UNITED STATES
NUCLEAR REGULATORY COMMISSION
WASHINGTON, D.C. 20565-0001

DRESDEN NUCLEAR POWER STATION, UNIT 2

AMENDMENT TO FACILITY OPERATING LICENSE

Amendment No. 140
License No. DPR-19

FIGURE 3.6.K-1

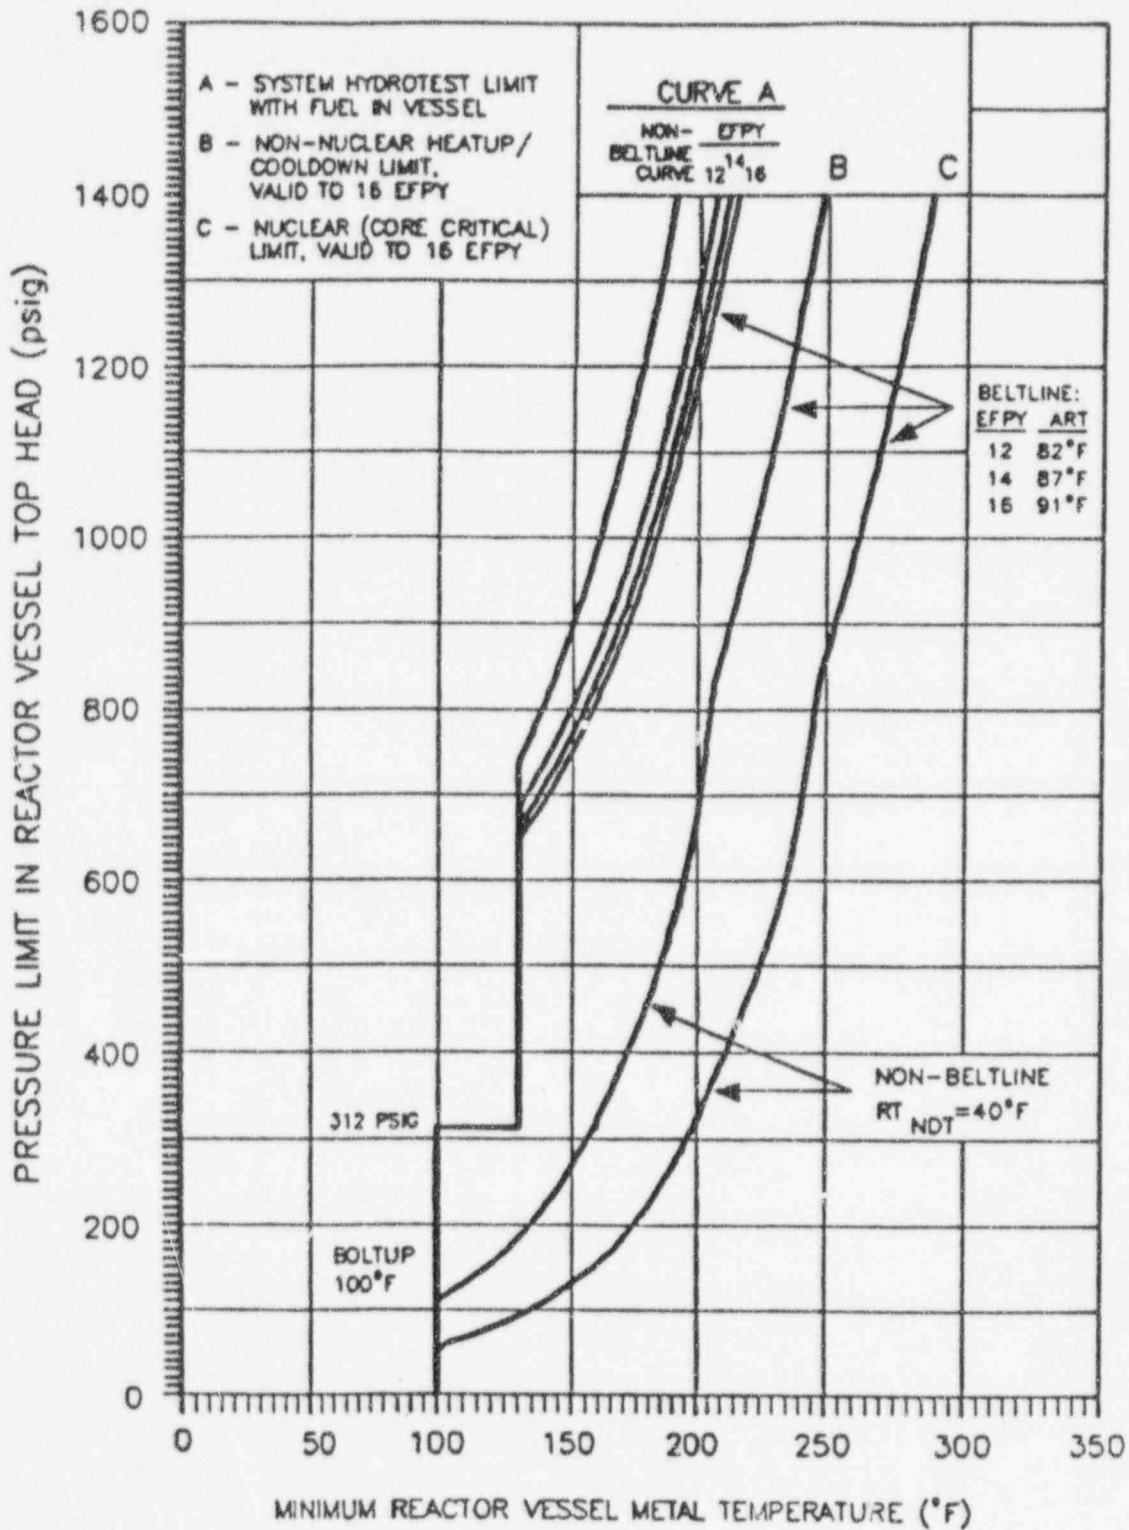
The reactor coolant system temperature and pressure shall be limited in accordance with the limit lines shown on Figure 3.6.K-1 (1) curve A for hydrostatic or leak testing; (2) curve B for heatup by non-nuclear means, cooldown following a nuclear shutdown and low power PHYSICS TESTS; and (3) curve C for operations with a critical core other than low power PHYSICS TESTS, with:

1. During system heatup, cooldown and inservice leak and hydrostatic testing operations, the reactor coolant system temperature and pressure shall be determined to be within the required heatup and cooldown limits and to the right of the limit lines of Figure 3.6.K-1 curves A, or B, as applicable, at least once per 30 minutes.

2. The reactor coolant system temperature and pressure shall be determined to be to the right of the criticality limit line of Figure 3.6.K-1 curve C within 15 minutes prior to the withdrawal of control rods to bring the reactor to criticality and at least once per 30 minutes during system heatup.

As indicated in curve A of Figure 3.6.K-1 for system hydrotesting, the minimum metal temperature of the reactor vessel shell is 100°F for reactor pressures less than 312 psig. This 100°F minimum boltup temperature is based on a RT_{NDT} of 40°F for the electroslag weld immediately below the vessel flange and a 60°F conservatism required by the original ASME Code of construction. At reactor pressures greater than 312 psig, the minimum vessel metal temperature is established as 130°F. The 130°F minimum temperature is based on a closure flange region RT_{NDT} of 40°F and a 90°F conservatism required by 10CFR Part 50 Appendix G

Curve B of Figure 3.6.K-1 applies during heatups with non-nuclear heat (e.g., recirculation pump heat) and during cooldowns when the reactor is not critical (e.g., following a scram). The curve provides the minimum reactor vessel metal temperatures based on the most limiting vessel stress. As indicated by the vertical 100°F line, the boltup stresses at the closure flange region are most limiting for reactor pressures below approximately 110 psig. For reactor pressures greater than approximately 110 psig, pressurization and thermal stresses become more limiting than the boltup stresses, which is reflected by the nonlinear portion of curve B. The non-linear portion of the curve is dependent on non-beltline and beltline regions, with the beltline region temperature limits having been adjusted to account for vessel irradiation (up to a vessel exposure of 16 EFPY). The non-beltline region is limiting between approximately 110 psig and 830 psig. Above approximately 803 psig, the beltline region becomes limiting.

Curve C, the core critical operation curve shown in Figure 3.6.K-1, is generated in accordance with 10CFR Part 50 Appendix G which requires core critical pressure-temperature limits to be 40°F above any curve A or B limits. Since curve B is more limiting, (curve C is curve B plus 40°F.

FIGURE 3.6.K-1

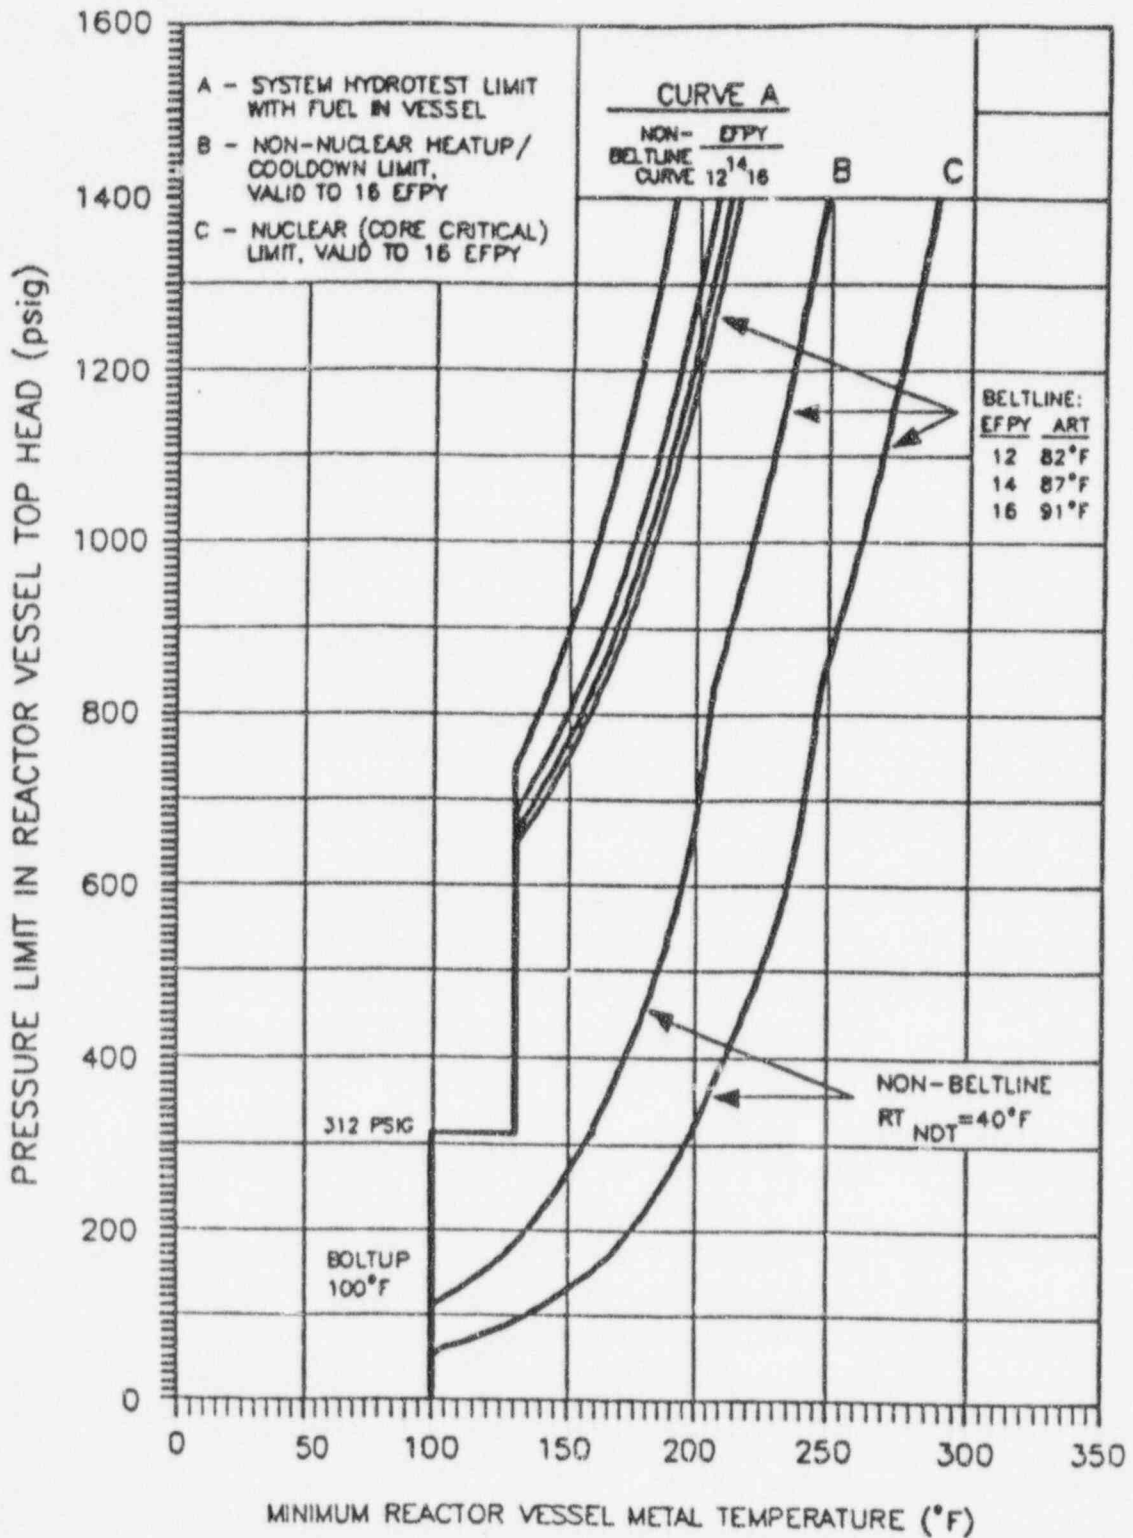
The reactor coolant system temperature and pressure shall be limited in accordance with the limit lines shown on Figure 3.6.K-1 (1) curve A for hydrostatic or leak testing; (2) curve B for heatup by non-nuclear means, cooldown following a nuclear shutdown and low power PHYSICS TESTS; and (3) curve C for operations with a critical core other than low power PHYSICS TESTS, with:

1. During system heatup, cooldown and inservice leak and hydrostatic testing operations, the reactor coolant system temperature and pressure shall be determined to be within the required heatup and cooldown limits and to the right of the limit lines of Figure 3.6.K-1 curves A, or B, as applicable, at least once per 30 minutes.

2. The reactor coolant system temperature and pressure shall be determined to be to the right of the criticality limit line of Figure 3.6.K-1 curve C within 15 minutes prior to the withdrawal of control rods to bring the reactor to criticality and at least once per 30 minutes during system heatup.

As indicated in curve A of Figure 3.6.K-1 for system hydrotesting, the minimum metal temperature of the reactor vessel shell is 100°F for reactor pressures less than 312 psig. This 100°F minimum boltup temperature is based on a RT_{NDT} of 40°F for the electroslag weld immediately below the vessel flange and a 60°F conservatism required by the original ASME Code of construction. At reactor pressures greater than 312 psig, the minimum vessel metal temperature is established as 130°F. The 130°F minimum temperature is based on a closure flange region RT_{NDT} of 40°F and a 90°F conservatism required by 10CFR Part 50 Appendix G

Curve B of Figure 3.6.K-1 applies during heatups with non-nuclear heat (e.g., recirculation pump heat) and during cooldowns when the reactor is not critical (e.g., following a scram). The curve provides the minimum reactor vessel metal temperatures based on the most limiting vessel stress. As indicated by the vertical 100°F line, the boltup stresses at the closure flange region are most limiting for reactor pressures below approximately 110 psig. For reactor pressures greater than approximately 110 psig, pressurization and thermal stresses become more limiting than the boltup stresses, which is reflected by the nonlinear portion of curve B. The non-linear portion of the curve is dependent on non-beltline and beltline regions, with the beltline region temperature limits having been adjusted to account for vessel irradiation (up to a vessel exposure of 16 EFPY). The non-beltline region is limiting between approximately 110 psig and 830 psig. Above approximately 803 psig, the beltline region becomes limiting.

Curve C, the core critical operation curve shown in Figure 3.6.K-1, is generated in accordance with 10CFR Part 50 Appendix G which requires core critical pressure-temperature limits to be 40°F above any curve A or B limits. Since curve B is more limiting, (curve C is curve B plus 40°F.
